Addendum #1

11/21/22

**project: Intermountain Healthcare
Layton Hospital – CT Remodel
201 Layton Parkway
Layton, UT 84041**

PROJECT: Layton Hospital CT Addition.

6 SEDATION 108 NORTH
 A401 scale: 1/4" = 1'-0"

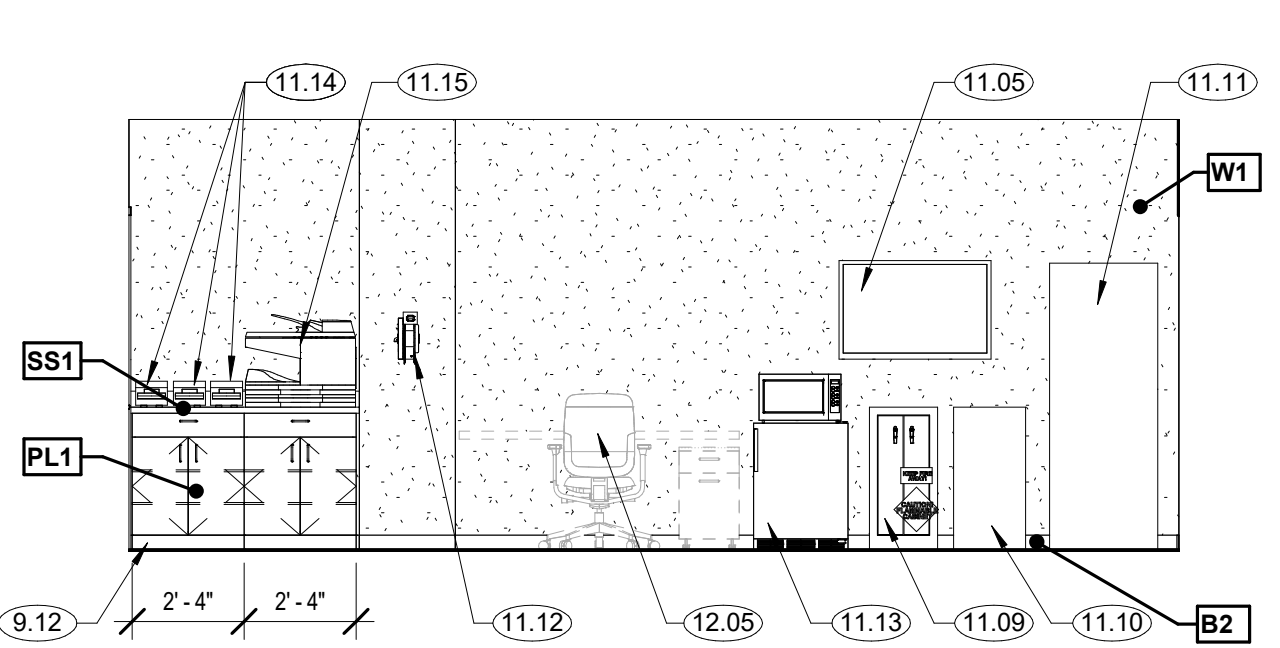
Response: PL1 will be Arborite W-46 EV Sulawesi Dunes (all cabinets)
PL2 will be the headwall in Sedation - Arborite W-465 EV Mocha Modern Cherry
SS1 will be Corian Whisper

See updated Finishes legend on A401 Interior Elevation and added PL2 tag on 6/A401.

1 LEVEL 1 - FINISH PLAN
 A603 scale: 1/4" = 1'-0"

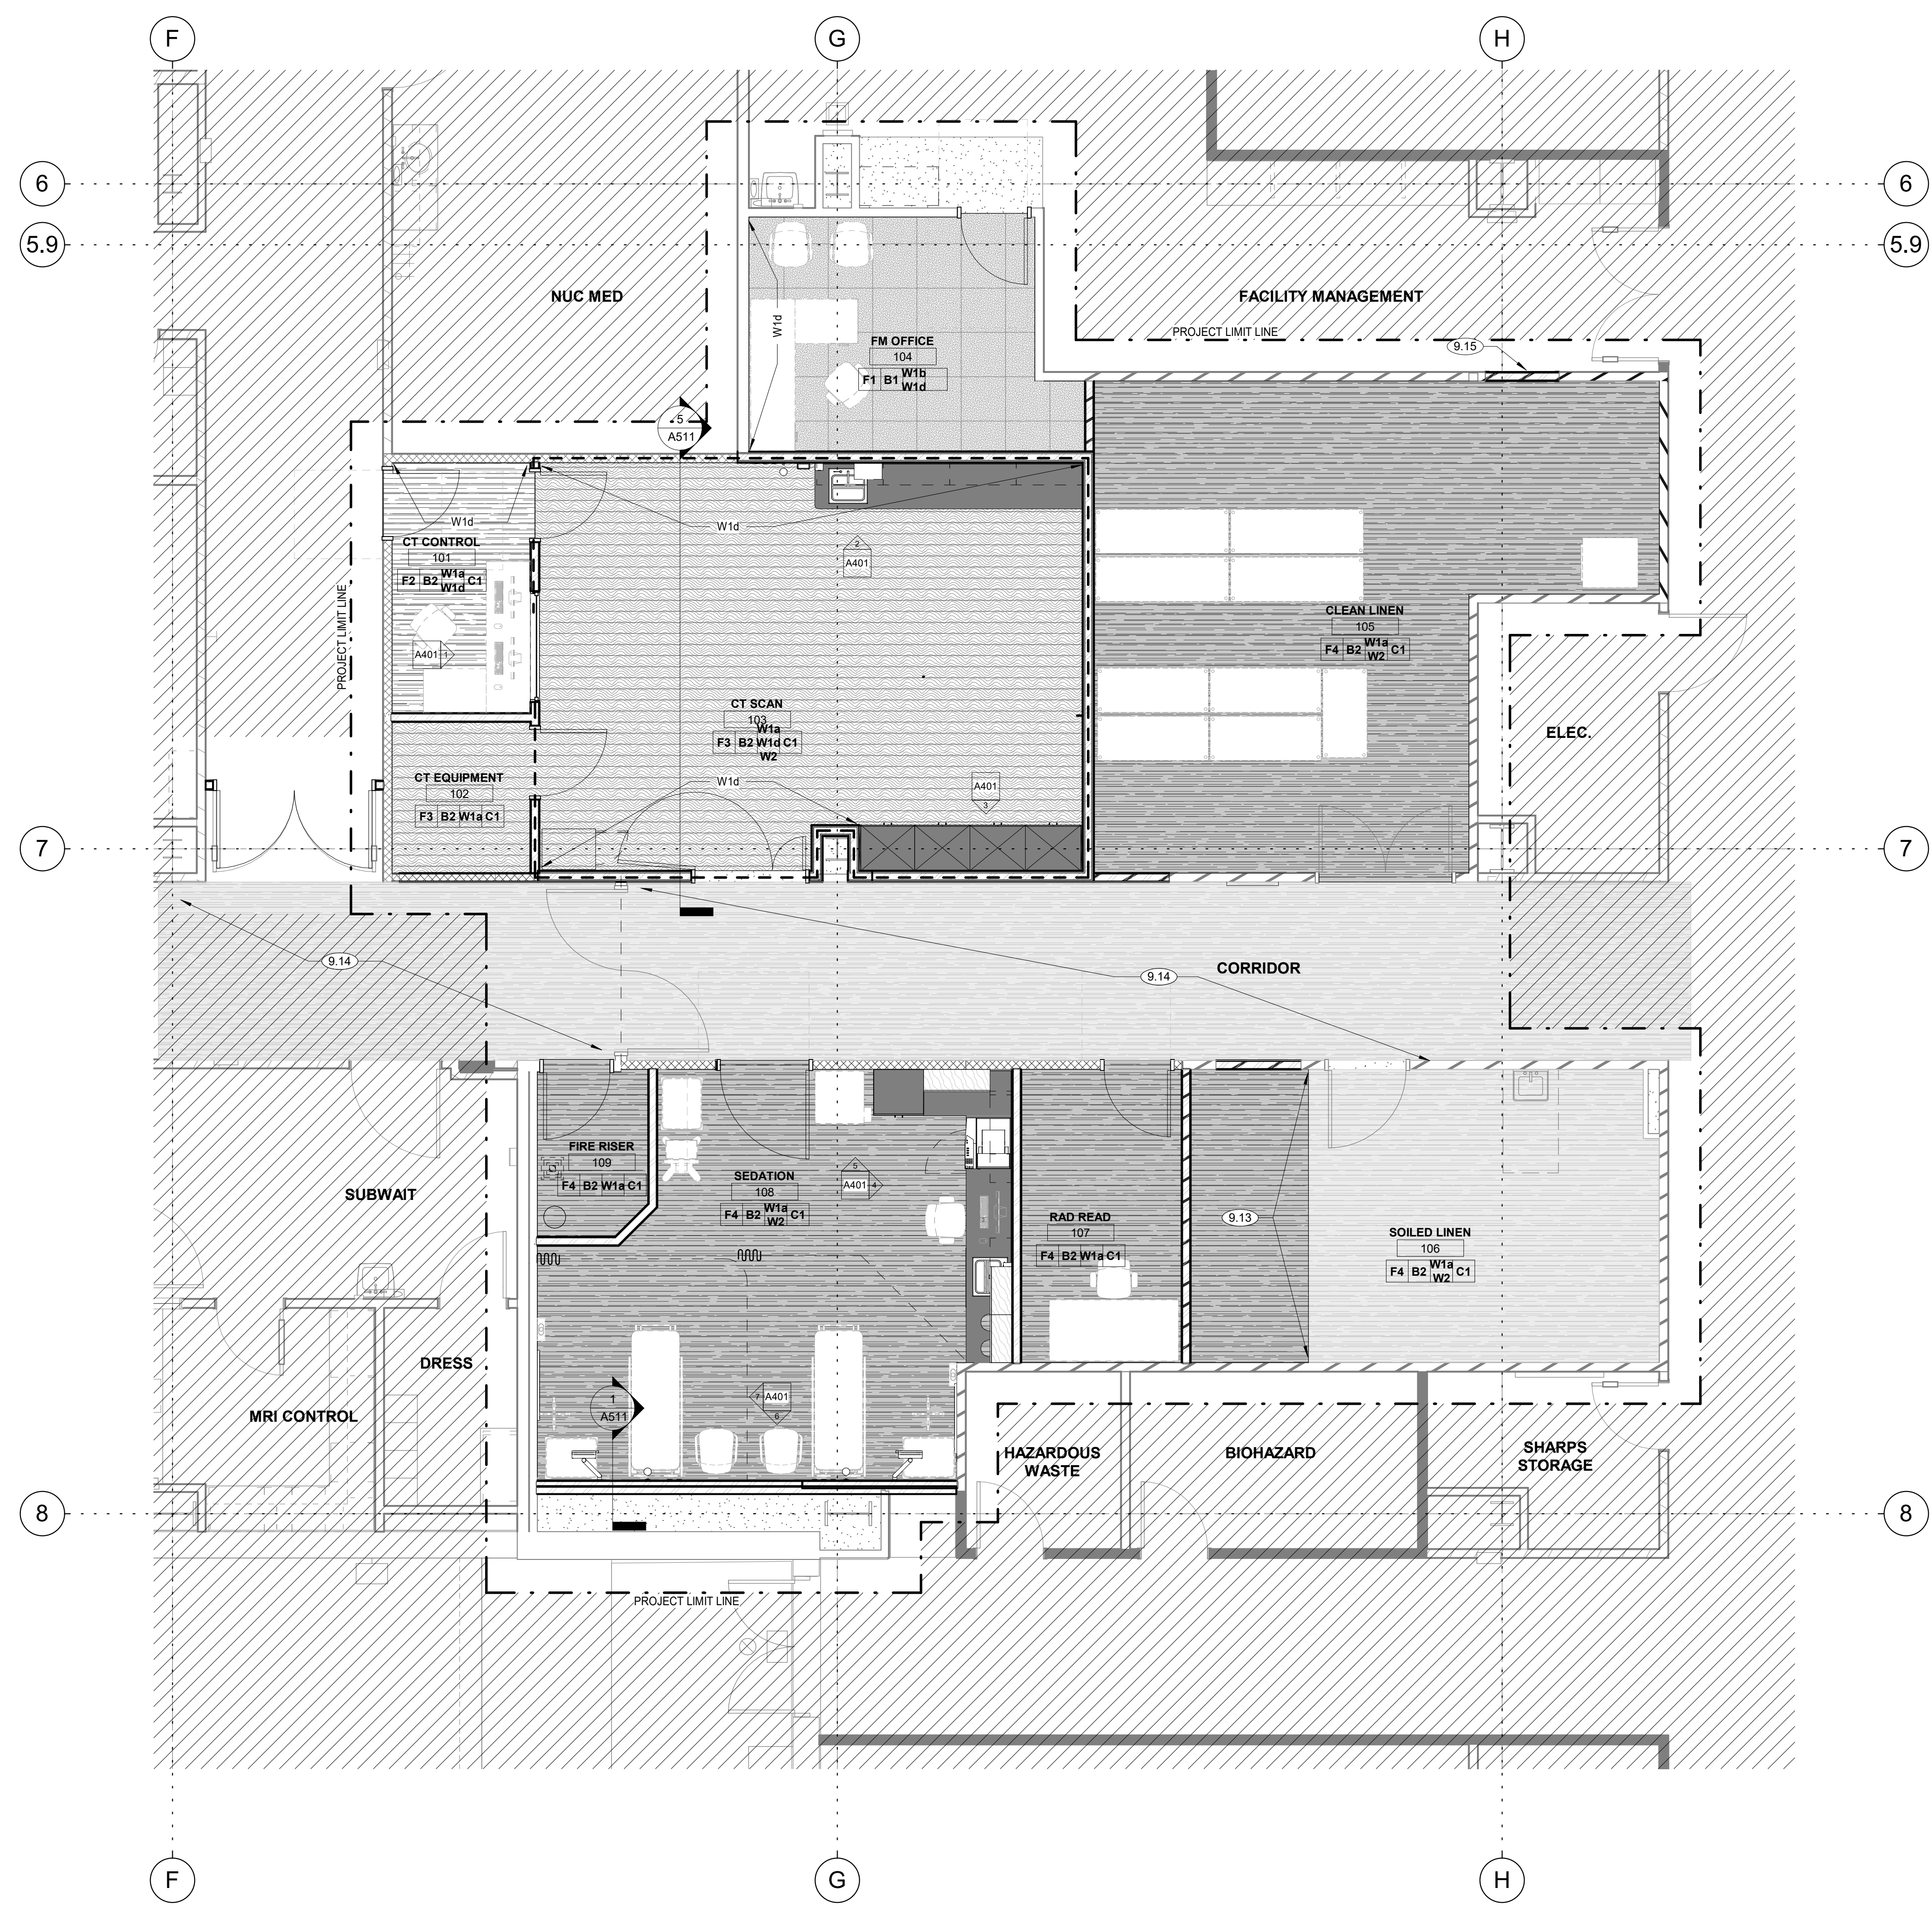
3. Question: F2 & F4 have the same exact description on the Floor Finish Legend. Just wanted to make sure this was correct. Are they supposed to be different colors of the same material? Also, the Soiled Linen Room 106 says F4, but the pattern matches F2.

Response: F4 is supposed to be the same material but different color compared to F2. It has been revised to call out color "ETW450 Dun".

In the Soiled linen room, we were trying to show that we are tying into existing. So the halftoned, light, flooring is existing and the room footprint is expanding and so we are extending the flooring. It is correctly called out as F4. If there is no background grey then it is F2 (F2 is in the CT Control room and the 3rd Floor rooms).

SHEET TITLE AND NUMBER:
MD103
 LEVEL 3 MECHANICAL
 DEMOLITION PLAN

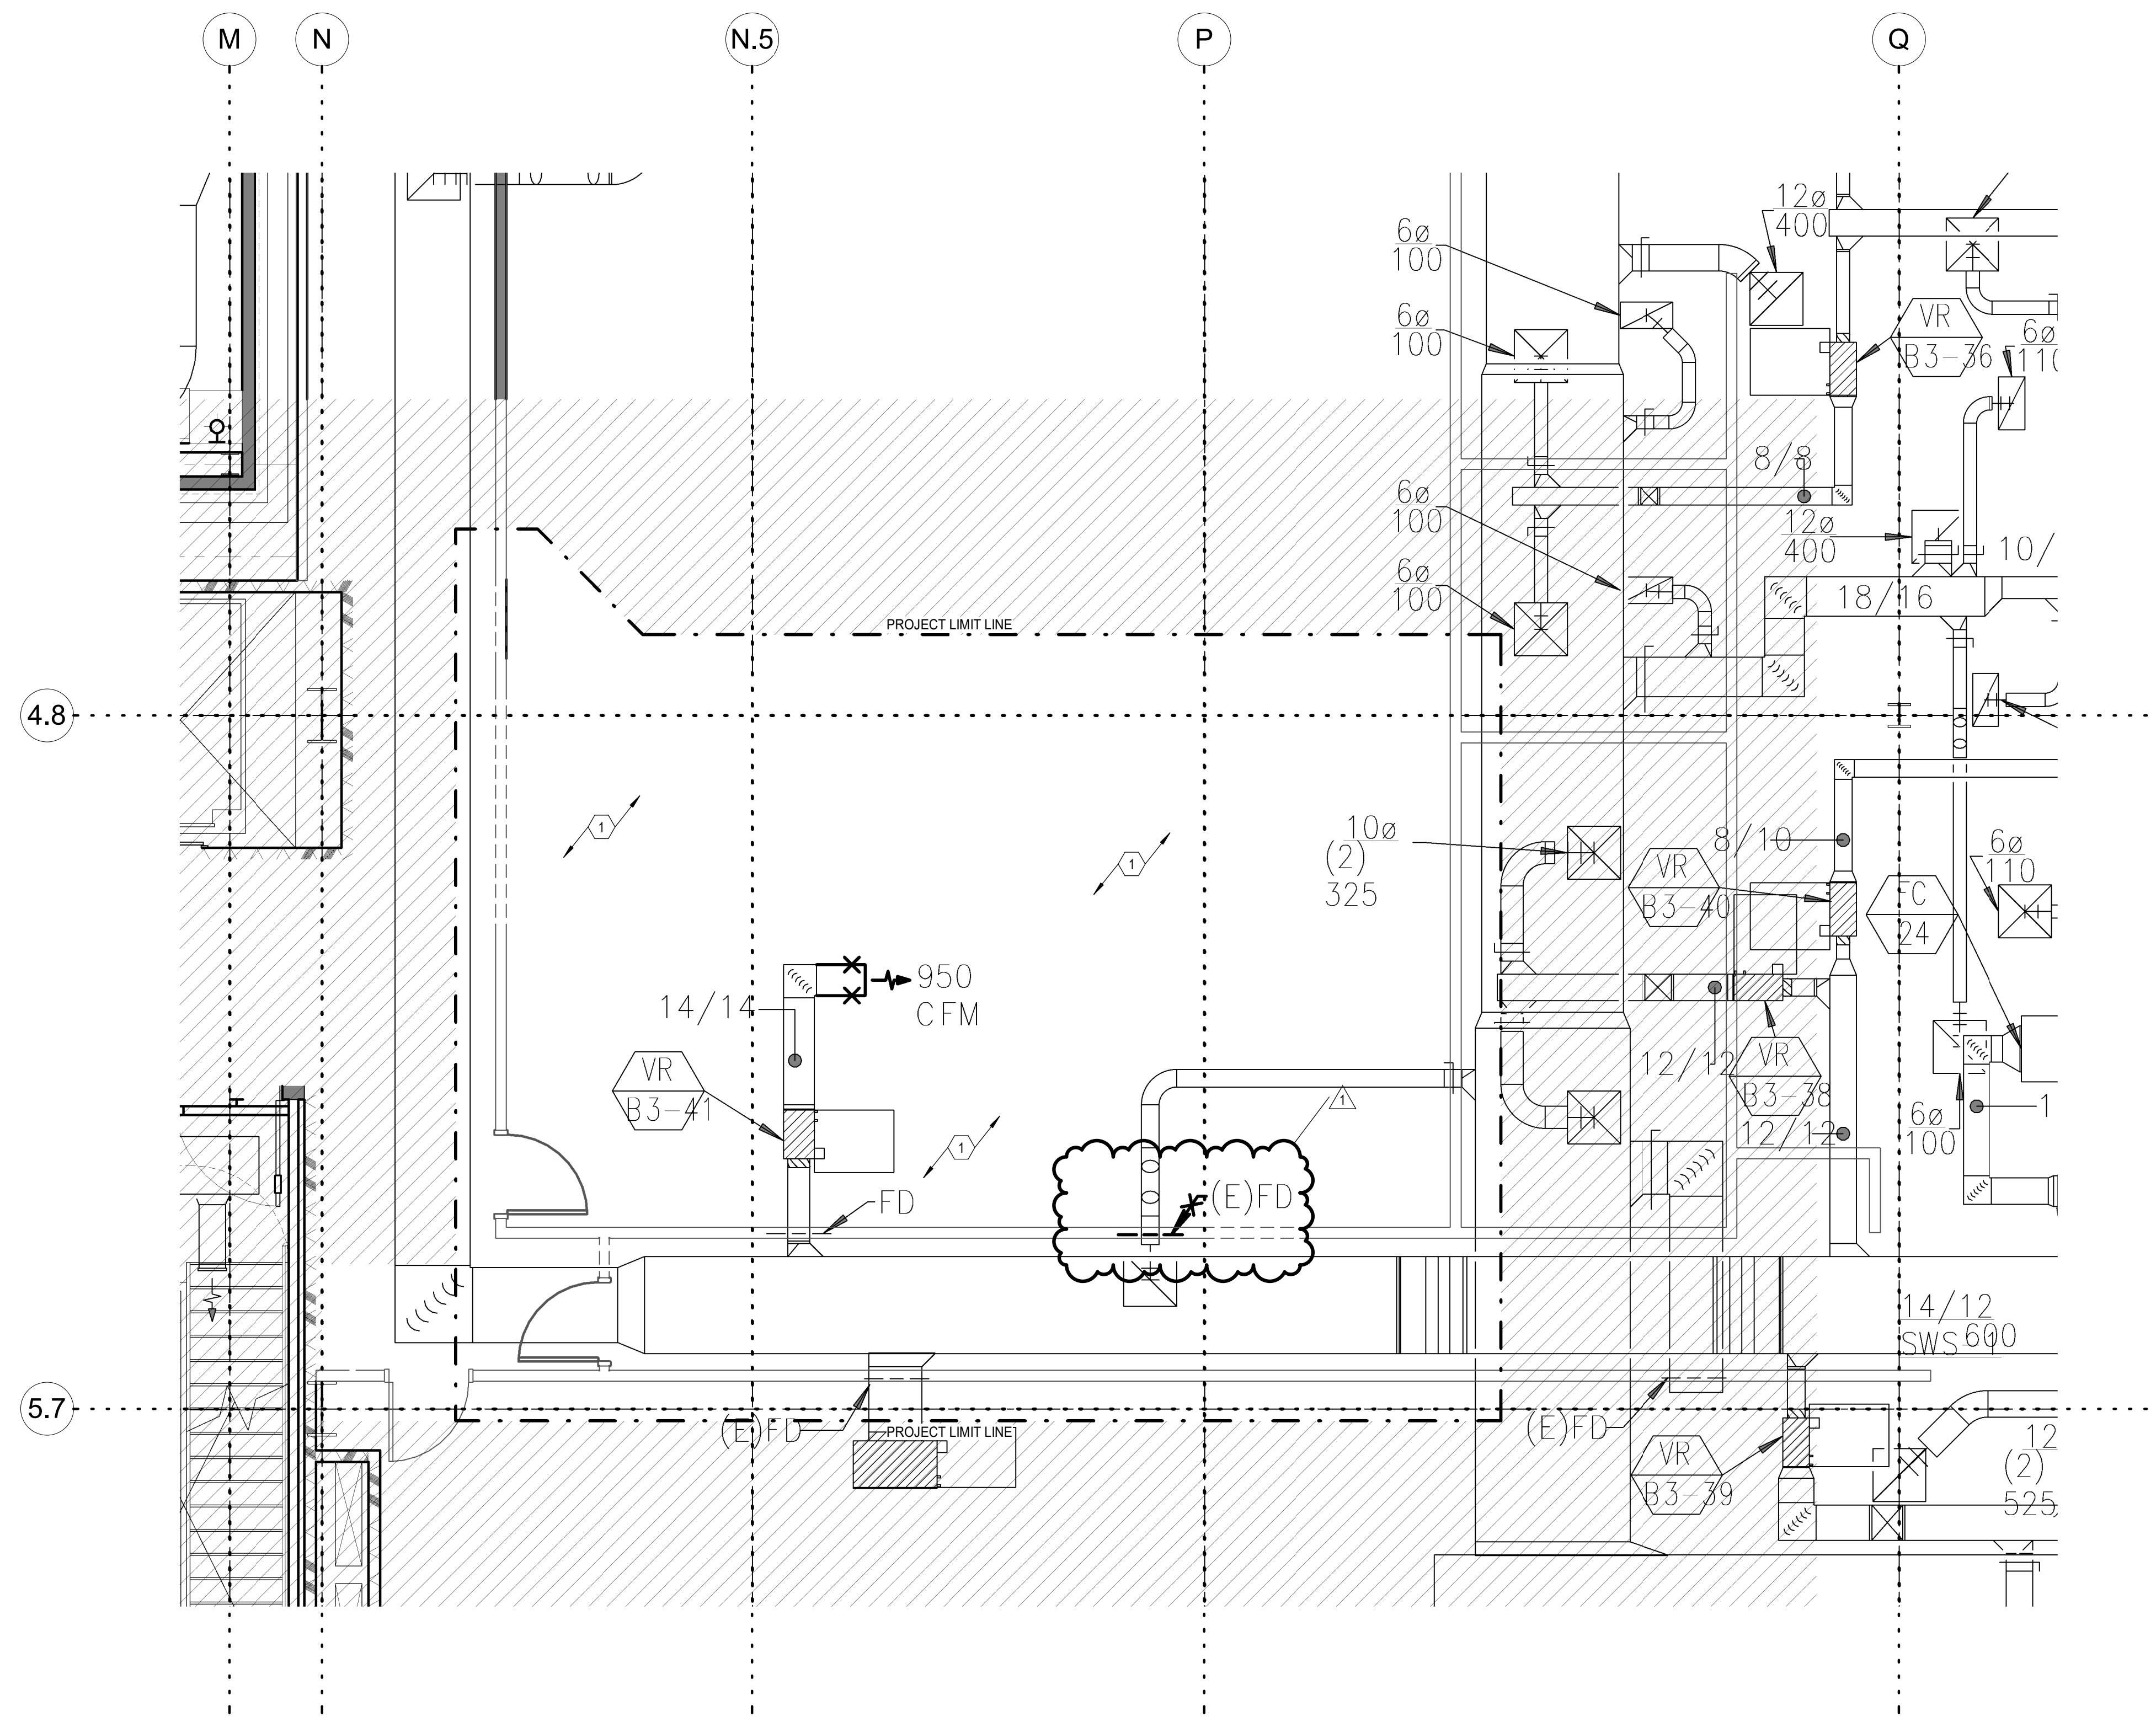
SHEET - MD103

1. Showed removal of existing fire damper to be replaced by combination fire/smoke damper.

- KEYNOTES**
- 1 CONTRACTORS TO COORDINATE FINAL LOCATION OF ALL DUCTWORK AND PIPING WITH EXISTING INSTALLATION. TYPICAL.
 - 2 REUSE EXISTING VAV BOX FOR NEW SYSTEM AND REBRAND TO CFM SHOWN.
 - 3 REMOVE EXISTING FIRE DAMPER AND INSTALL NEW COMBINATION FIRE SMOKE DAMPER
